BEACON PLANNING BOARD One Municipal Plaza - Courtroom BEACON, NEW YORK 12508

The Planning Board will meet on **Tuesday, February 11, 2020** in the Municipal Center Courtroom. A work session will take place at 7:00 PM for a training workshop, discussion of agenda items and/or topics of interest to the Planning Board. The regular meeting will begin immediately thereafter, but not later than 7:30 p.m.

Re: Response to John Clarke Comments dated 01/10/2020, and Lanc & Tully Comments dated 01/08/2020, 248 Beacon Holdings LLC - Fishkill Creek Development Site Plan for 248 Tioronda Avenue (Formerly Beacon 248 Development, LLC, Multifamily Development) 248 Tioronda Avenue, City of Beacon, Dutchess County, NY Chazen Project #81750.00

date scale
09/10/18 AS SHOWN
project no.
81750.00 sheet no. C161 7 of 17

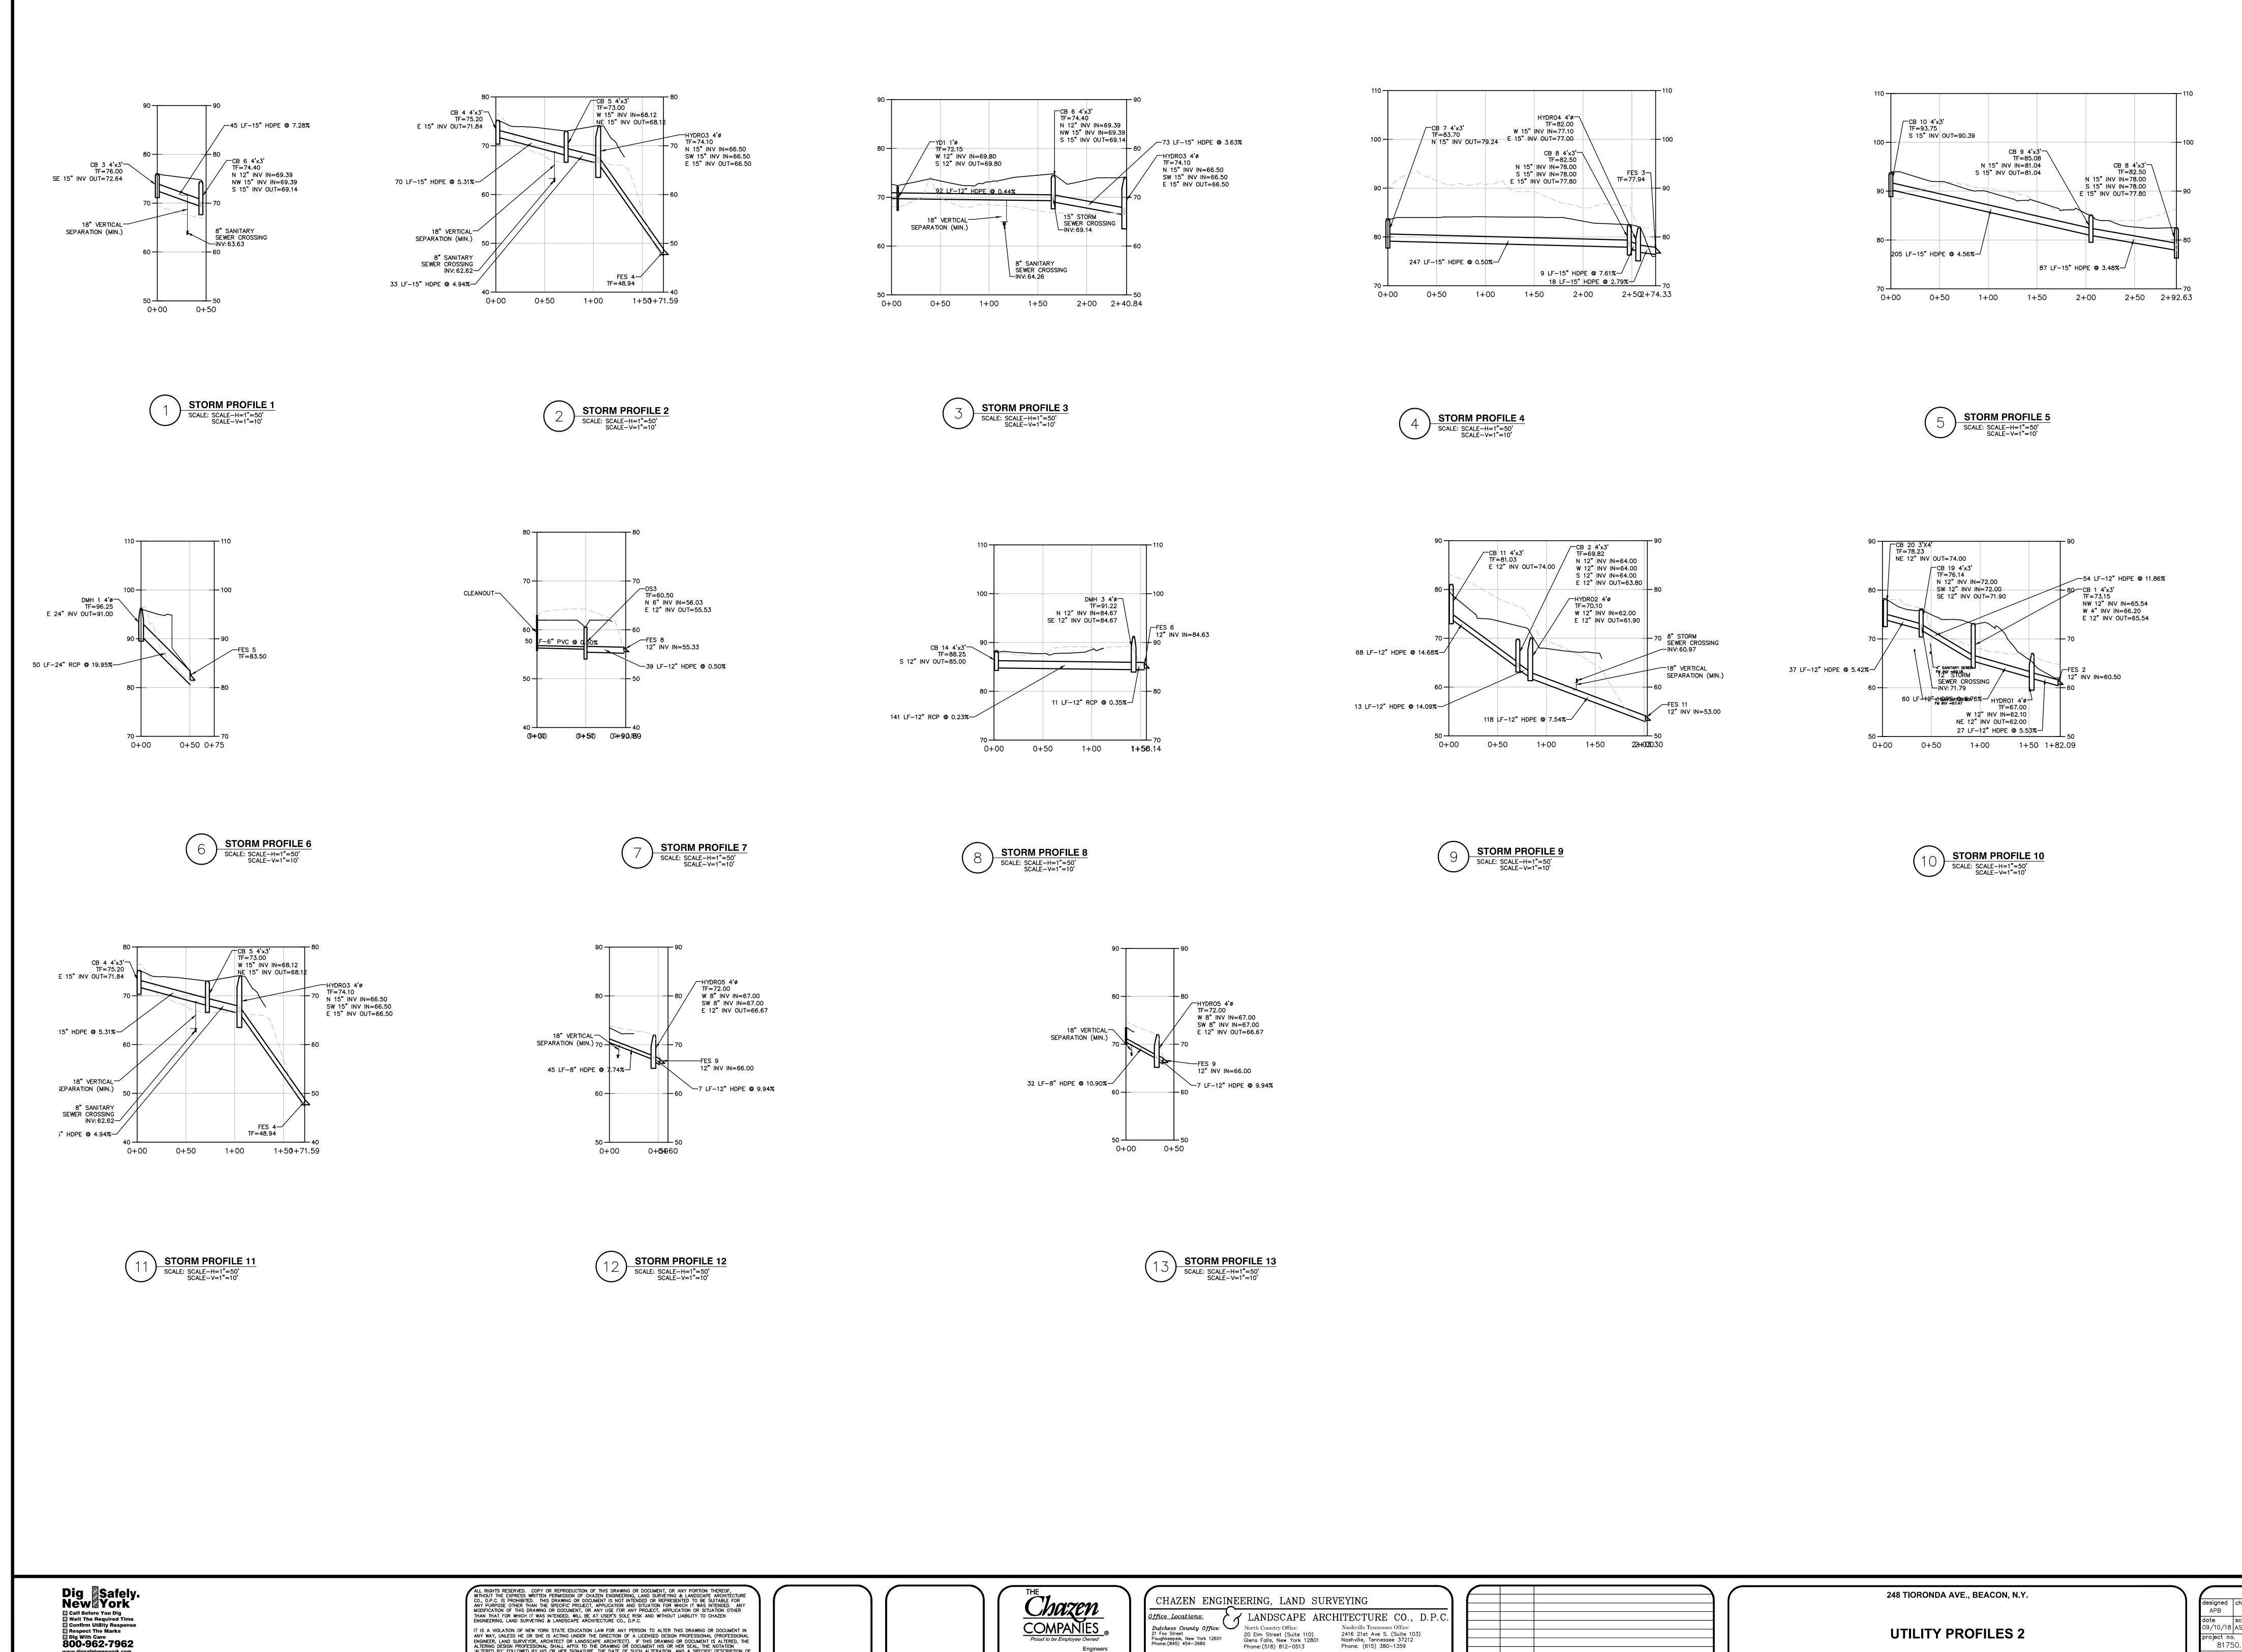
Sheet C161- Utility Profiles:

3. The watermain profile should be updated to show the crossing between CB-11 and CB-2.

1. On the Watermain Profile, it states that there is a 45-degree horizontal bend at Station 5+98. There is no bend shown on Sheet C160 at that stationing. Therefore, the label should be removed.

Response: The crossings have been added to the profile.
